ControlLogix Sequence of Events Input Modules, Firmware Revision 2.009

Catalog Numbers 1756-IB16IS0E, 1756-IH16IS0E

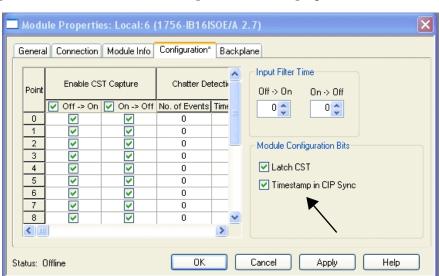
There are now two Per Point Comm Format selections: CIP Sync Per Point and CST Per Point.

Choosing either Per Point Comm Format results in an input tag structure with a single On and Off timestamp value per input point, as well as some additional general-purpose CIP Sync status tags.

However, choosing the CIP Sync Per Point option results in the creation of two additional input tags to assist in timestamp corrections in a CIP Sync architecture: I:LocalClockOffset and I:OffsetTimestamp. The Comm Format selection does **not** define whether the module timestamps by using CST or CIP Sync values. It only affects what tags are generated.

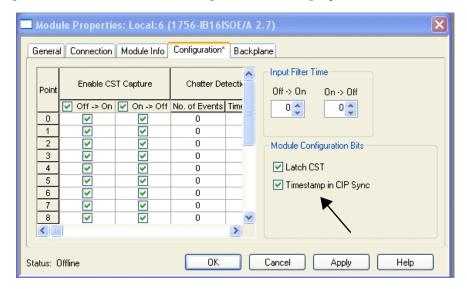
However, choosing the CIP Sync 10x FIFO Mode option results in the creation of a 10 element array in the input tag area to facilitate the retrieval of 10 timestamp events per RPI (as shown below).

The CIP Sync 10x FIFO Mode option also results in the creation of two additional input tags to assist in timestamp corrections in a CIP Sync architecture: I:LocalClockOffset and I:OffsetTimestamp.

The Comm Format selection does **not** define whether the module time stamps by using CST or CIP Sync values. It only affects what tags are generated. This means that you can use the x10 retrieval mechanism and still time stamp in CST. See below for details.

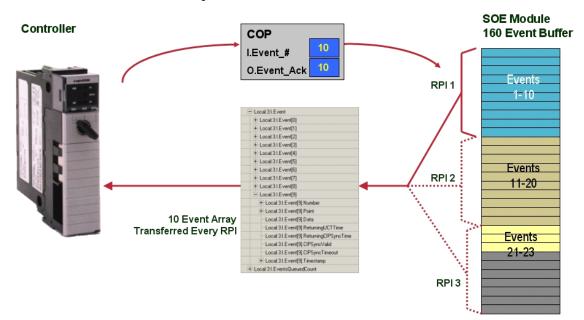
The retrieval mechanism for x10 FIFO mode operation operates exactly as it has in the past, with the obvious exception of transferring 10 events instead of 1 per update.

As mentioned, an array of 10 elements is now provided in the Input tag structure, and each element contains an Event Number tag as shown below.
